## Comments on “**Preliminary Estimates of Loads to the Refuge After STA-1E is in Operation, DRAFT – May 12, 2005**” by Dr. Gary Goforth

The comments compiled here are from individual DOI technical staff and consultants. They are not comprehensive and have not undergone extensive internal review. Although we agree with many parts of the document, our failure to comment on a specific item does not imply concurrence. Our purpose is to help work toward a better understanding of the near-future management challenges, future remedies, current and future opportunities, risks to water quality, and quantitative expectation of restoration of Refuge lands.

Figure 1. Volume of water not previously entering the Refuge under the “Existing” scenario, and percent of total inflow that is new. The new water sources are the L-8 and C-51W Basins. Percent new is the percent of total inflow volume.

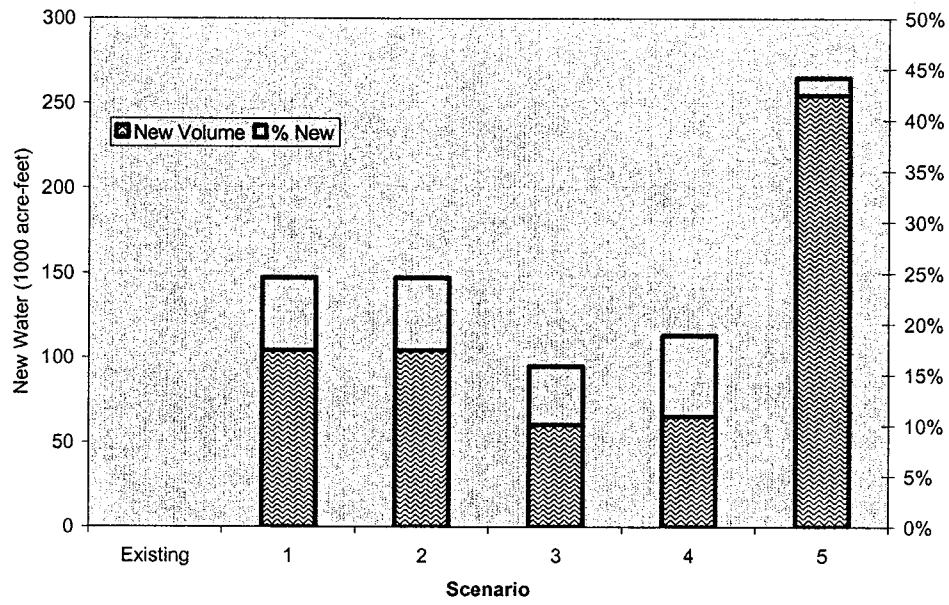
Indeed, STA-1E operation is anticipated to bring in significant sources of new water, likely over 100,000 acre-feet (Fig. 1) with its associated load to the STAs as well as to the Refuge (Figs. 2, 3). Thus, under some reasonable scenarios, STA-1E operations present an added challenge for the treatment systems at a time when we are searching for ways to improve Refuge water quality. The Refuge does support the STA-1E project. STA-1E will bring added water volume to the EPA, and will give added flexibility to managers. However, in our opinion, its construction delay is not the chief cause of excessive TP loading to the Refuge, and its operation will not solve the water quality difficulties facing the Refuge.

Figure 4. Total annual inflow volume to the Refuge under the extended set of alternatives.

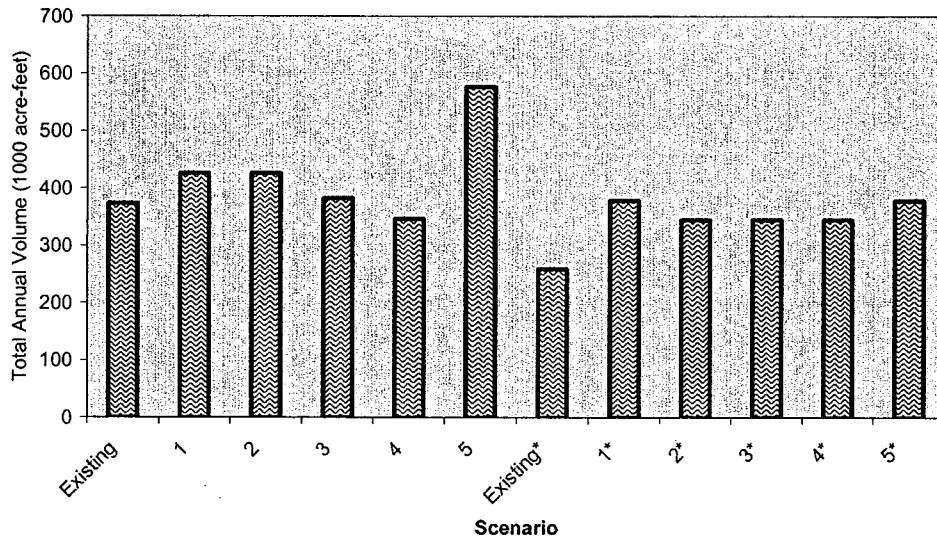
The Goforth report presents optimistic scenarios in its projection of future treatment efficiency. This is particularly true if we consider startup and stabilization periods when, especially during startup, draft permitted concentrations may be well in excess of 100 ppb. There is considerable uncertainty concerning the level of treatment that will be achieved. There is additionally a considerable uncertainty in the volume of flow that will be treated caused by climatic variability and present uncertainty about flow management. As an example of an alternative, but quite plausible, scenario set, consider the following set of six scenarios:

These alternative scenarios are based on the assumption that treatment volumes are restricted to 180, and 165 thousand acre-feet for STA-1W and STA-1E respectively.<sup>1</sup> For the "Existing\*" scenario, it is additionally assumed that STA-1W flow is increased by 20 thousand acre-feet to account for net flow that under the STA design would have been transferred to STA-1E from STA-1W. Consistent with the state's draft definition of an STA TBEL, it is additionally assumed that treatment is only able to achieve 50 ppb TP concentration as a long-term average at these design flows. This set of scenarios then leads to alternative projections (Fig. 4 and 5). Even with limited treatment volumes, loads discharged to the Refuge may not be significantly reduced in the future without additional actions.
